ECN/PCN No.: M1389

Product Description: <b>Low Profile Shielded SMD Chip Power Inductor</b>	Abracon Part Number / Part Series: <b>ASPI-0615FS Series</b>	<input type="checkbox"/> Documentation only <input checked="" type="checkbox"/> Series <input checked="" type="checkbox"/> ECN <input type="checkbox"/> Part Number(s) <input type="checkbox"/> EOL
Affected Revision: <b>F</b>	New Revision: <b>G</b>	Application: <input type="checkbox"/> Safety <input checked="" type="checkbox"/> Non-Safety

Prior to Change:

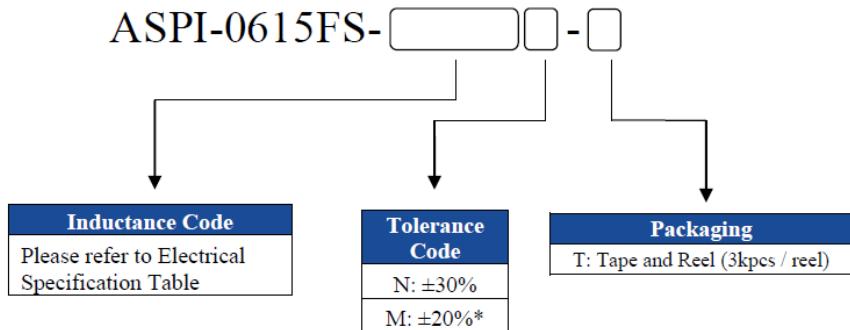
### 4.0 Part Number Identification

### 8.0 Packing

**T: 3,000pcs / reel**

Reverting part number 'T' suffix to 'T2' and SPQ=2Kpcs

After Change:

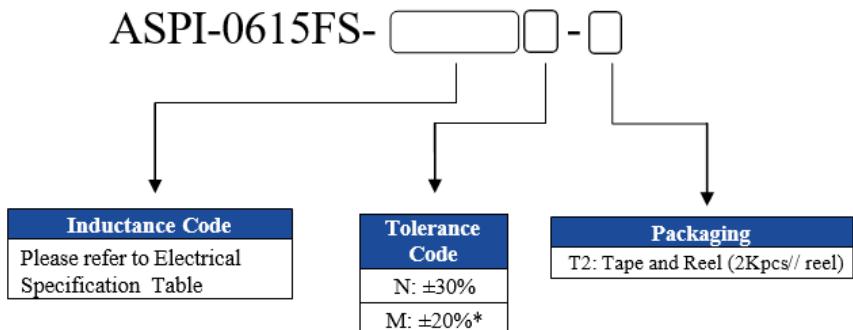
### 4.0 Part Number Identification

### 8.0 Packing

**T2: 2,000pcs / reel**
